Heather Godsmark

Swallowfield, Eastergate Lane, Eastergate, Chichester, West Sussex

This revised objection issued 13.06.20- UPDATED By deleting unwanted text and new text inserted in red.

## OBJECTION

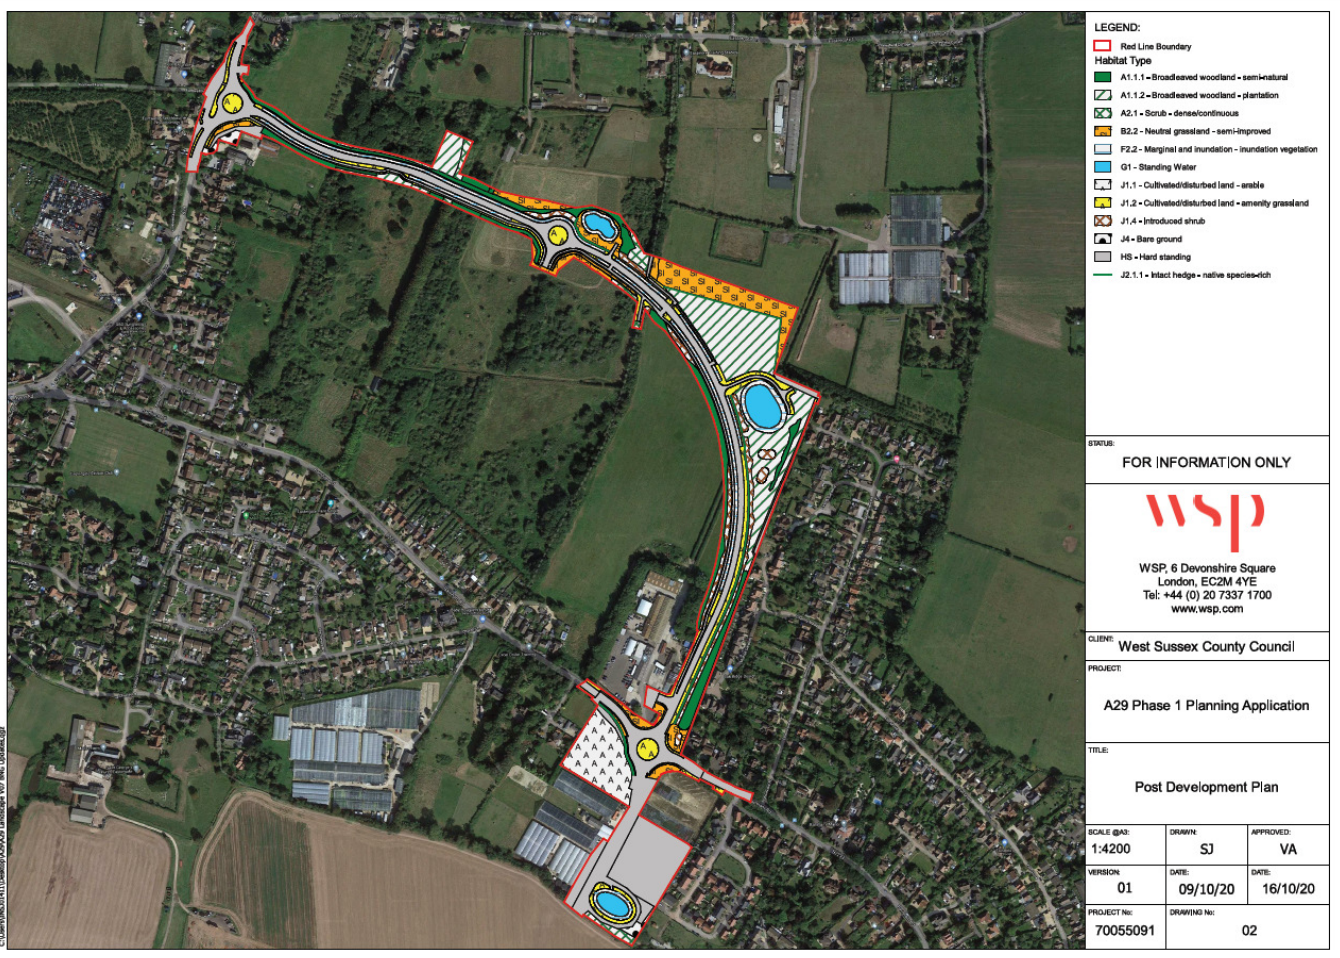
The above Semi-natural and Plantation Broadleaved Woodland patterns, existing habitat identities, (solid Green and Green horizontal stripes), are carried forward for use on the Post Development Plan, to identify proposed mitigation habitat types, taken from the application landscape drawings.

App 9.10 (Bio Diversity Net gain Assessment Final) stated that the Post-Development Habitat Plan was digitised from the WSP Soft Landscape Plan drawing no. A29-WSP-LAGA-001 - Version 7-06.10.20 (WSP, 2020) received on 05 October 2020.
